HISTORIC AND DESIGN REVIEW COMMISSION

July 17, 2019

HDRC CASE NO: 2019-365
ADDRESS: 517 E HOUSTON ST
LEGAL DESCRIPTION: NCB 422 BLK 26 W 26 FT OF 5 ARB A2
ZONING: D,HS, H
CITY COUNCIL DIST.: 1
DISTRICT: Alamo Plaza Historic District
LANDMARK: Rosenberg, Frank Building
APPLICANT: Michael Litofsky
OWNER: Michael Litofsky
TYPE OF WORK: Storefront Modification
APPLICATION RECEIVED: June 24, 2019
60-DAY REVIEW: August 23, 2019
CASE MANAGER: Huy Pham
REQUEST:

The applicant is requesting a Certificate of Appropriateness for approval to modify a previously approved design to include a glass storefront on the E Houston Street side.

PROPOSED - JULY 2019

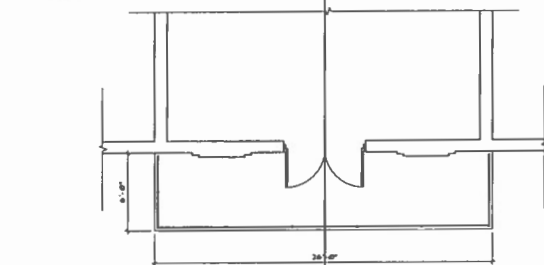
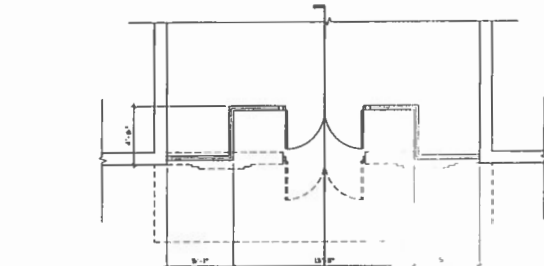
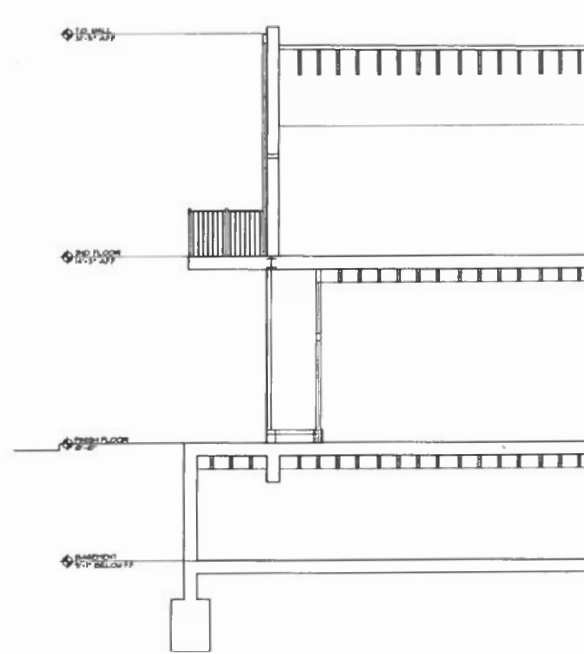
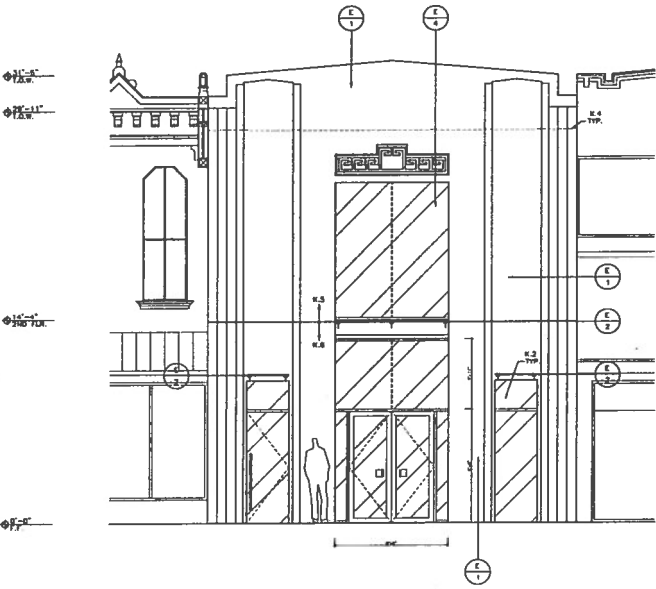
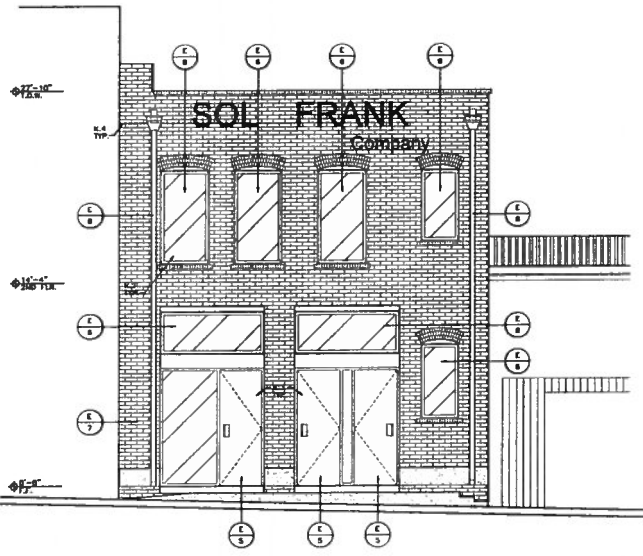
- c. **DESIGN AMENDMENT** – The applicant has proposed to install a full-glazing first-floor storefront and a

second-floor balcony with railing and centered entry. Staff finds that the proposed design would create condition where the first-floor storefront does not relate to the second-floor façade and that the proposed balcony with railing is disruptive to the Art Moderne rhyme of the flanking pilasters. Staff finds that the proposed design amendments are inconsistent with the Guidelines for Exterior Maintenance and Alterations 10.A.i and 10.B.i. and that the previously approved design is a more sensitive and appropriate treatment of the structure.

Staff does not recommend approval of the design amendment based on finding c. The applicant may submit another design that is consistent with the Guidelines or based on historic photographic evidence to be submitted for review – or continue with the design approved in May 2015 and again in May 2019.

1.A2.1 SOUTH ELEVATION
SCALE: 1/8" = 1'-0"

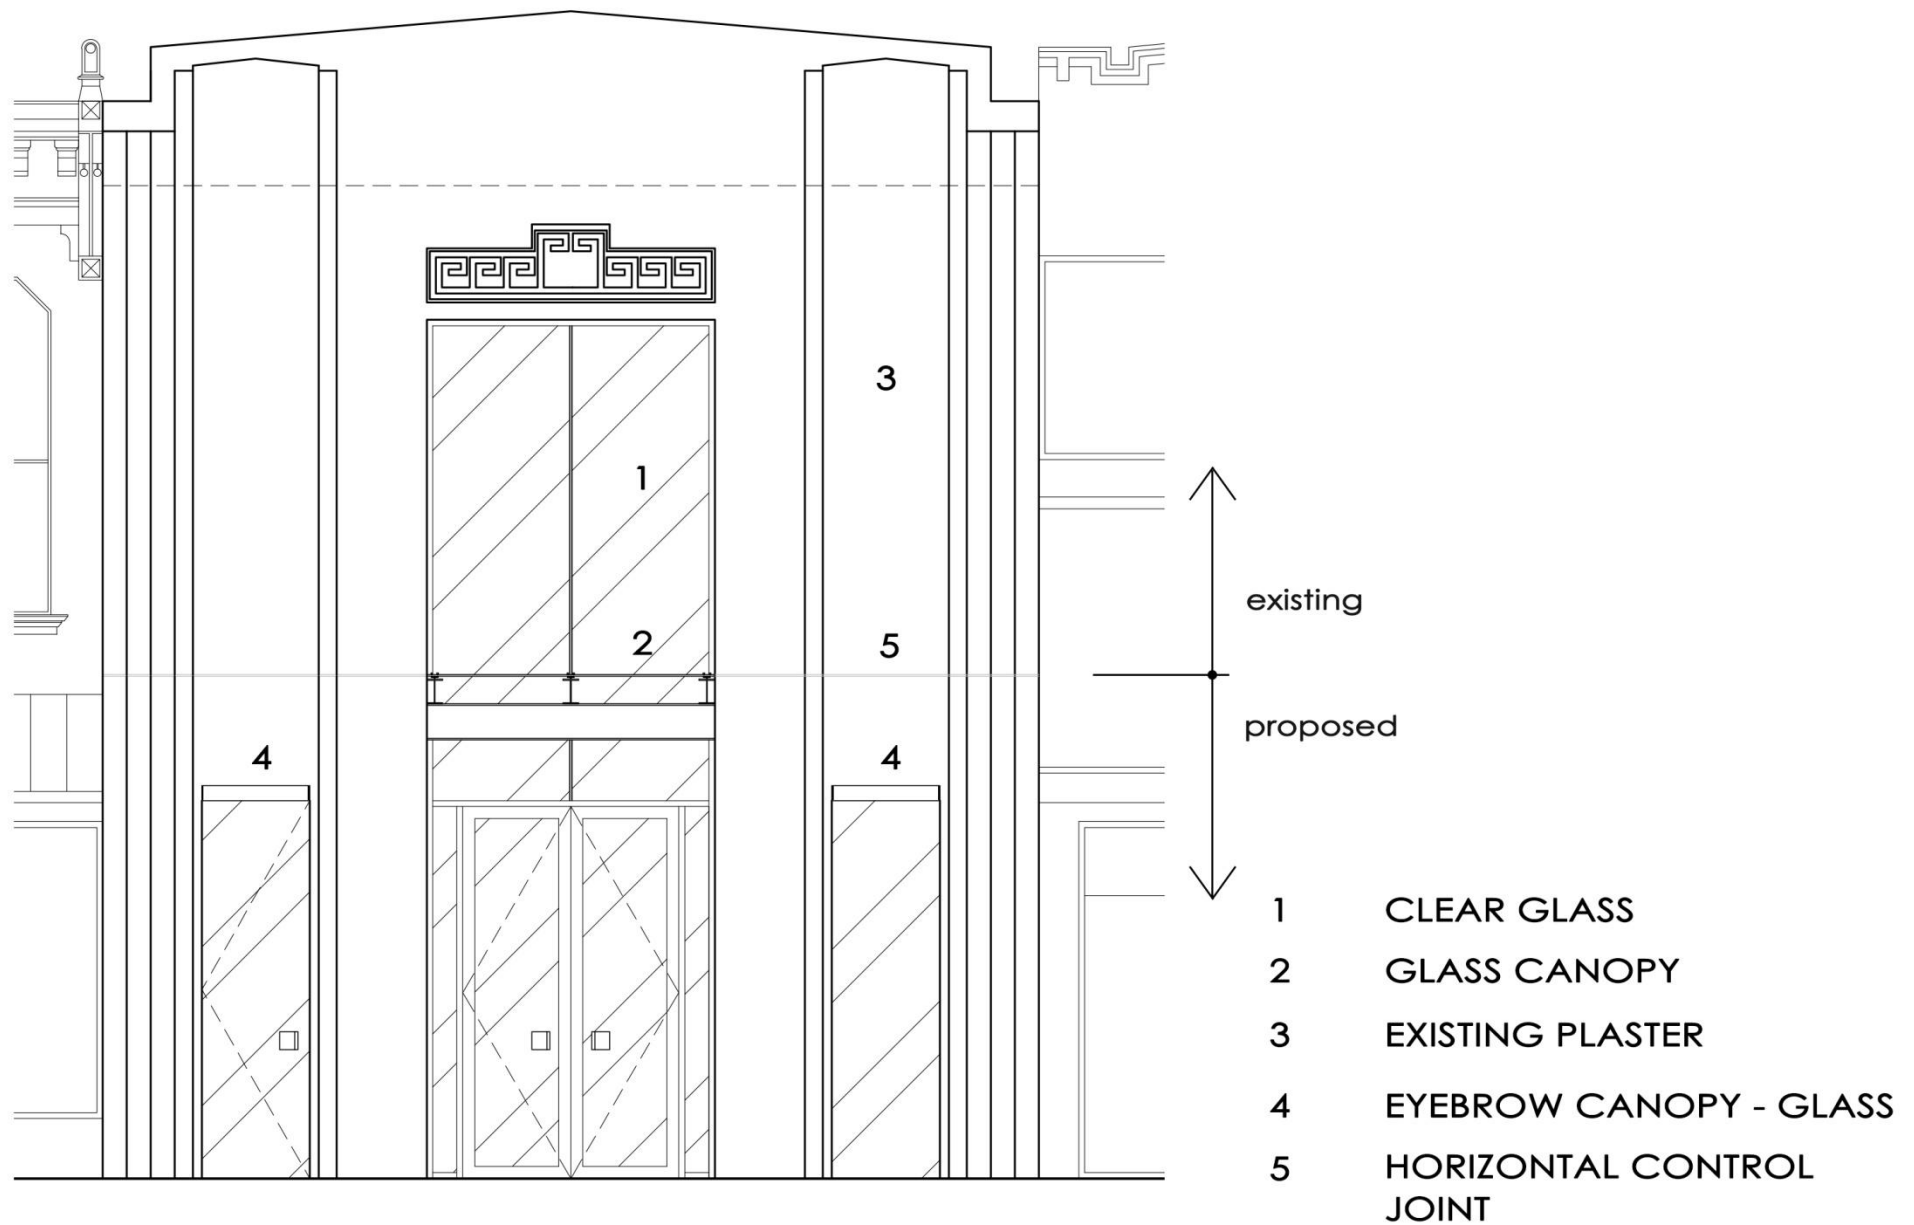
- i. SECOND FLOOR WINDOW - The applicant has proposed to install clear glass on the Houston Street façade where a second level clear storefront glass would have once been located. The Guidelines for Exterior Maintenance and Alterations 10.A.iii. states that missing features should be replaced in to match the style of the building and the period in which it was designed. Staff finds that the applicant's proposal is appropriate and consistent with the Guidelines.

- j. CANOPY - Per a photograph dated October 2007, the Houston Street façade at 517 Houston featured a canopy which projected approximately eight (8) feet out over the sidewalk, which has since been removed. The applicant has proposed to install a projecting steel and glass canopy which is to extend over the sidewalk approximately five (5) feet and feature three (3) sections to correspond with the entrance way and the proposed new clear glass. While the profile and materials are not alike in materials to the original historic façade, staff finds that the light appearance of the thin steel and glass canopy does not distract from the historic façade and is appropriate in this instance.

- k. STOREFRONT - While currently covered by plywood, the storefront façade at 517 E Houston features a recessed storefront entrance. Other storefront entrances on E Houston do not feature entrances nearly as deep as this one, which leads staff to believe that 517 E Houston's storefront entrance is not an original element of the building's design. The applicant has proposed to alter the storefront entrance to become more consistent with other storefront setbacks along E Houston. Staff finds that this request appropriate.

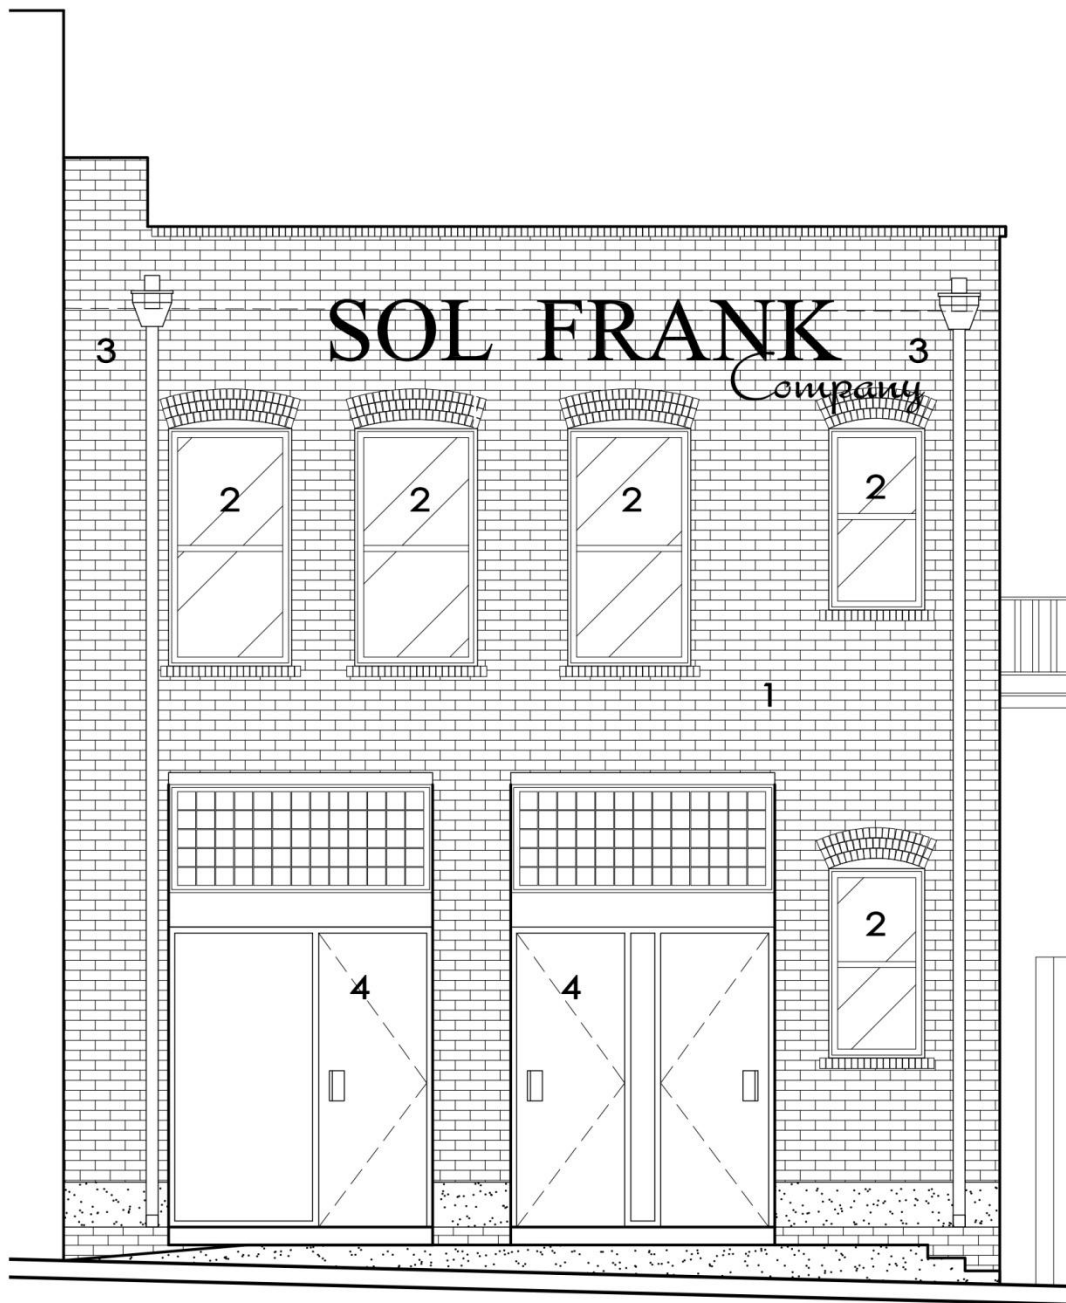
- m.** NEW DOORS - The applicant has proposed to install two (2) new doors on the Peacock Alley façade. While this is the rear of the building, in this instance the rear is proposed to be treated as the front also. The Guidelines for Exterior Maintenance and Alterations 6.A.i. does not recommend that new entrances be created where visible from the public right of way. This proposal is not consistent with the Guidelines. Staff recommends that the applicant keep the existing door openings and widths.

- 1 CLEAN AND RESTORE EXISTING BRICK
- 2 REPLACE WINDOWS
- 3 RESTORE SCUPPER, DOWNSPOUT AND DOWN LEADER
- 4 NEW DOORS
